Item Number 21b**ER Section 2.5.3****Request:**

Describe the cultural background (prehistoric and historic) at the Calvert Cliffs site to put the historical properties in context. Provide this in the Phase II report planned for completion in August 08.

(New) Figure 9.3-2: Candidate Area Exclusionary Criteria and Region of Interest – Maryland

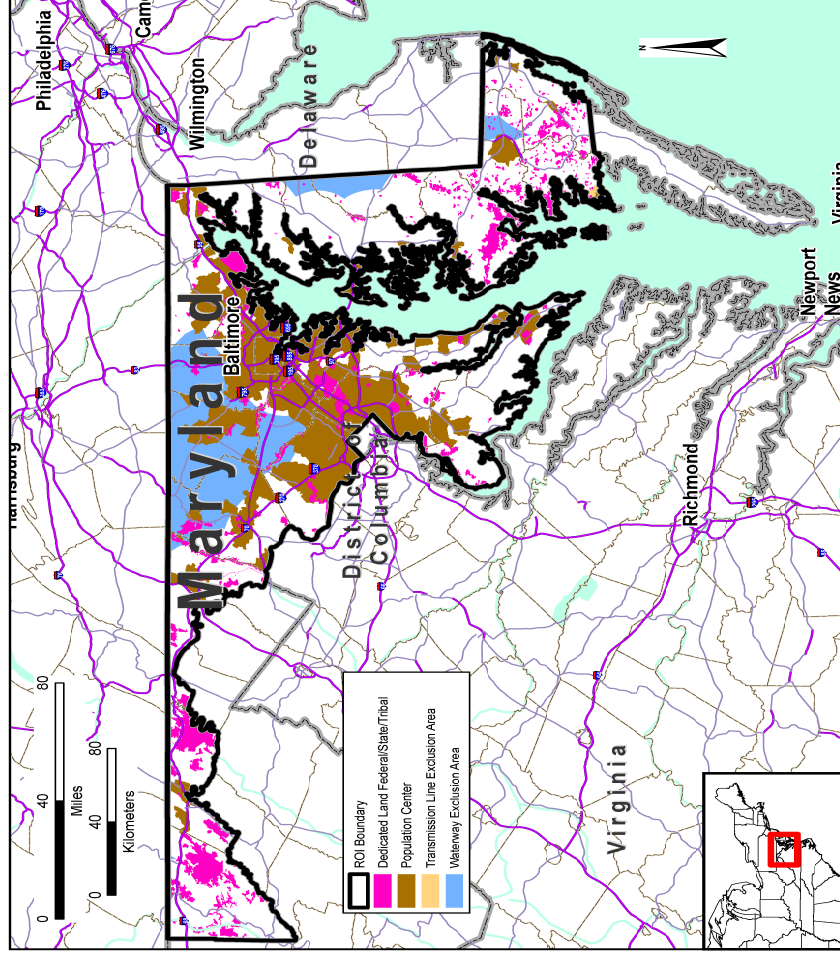
Section 9.3.1.2 of the ER is not clear on what candidate areas were considered. Provide more specific detail of candidate area and potential site selection process.

In response to this RAI, the following information will be incorporated into ER Section 9.3.1.1:

Figures 9.3-1 and 9.3-2 show the application of the exclusionary criteria within the ROI for New York and Maryland, respectively.
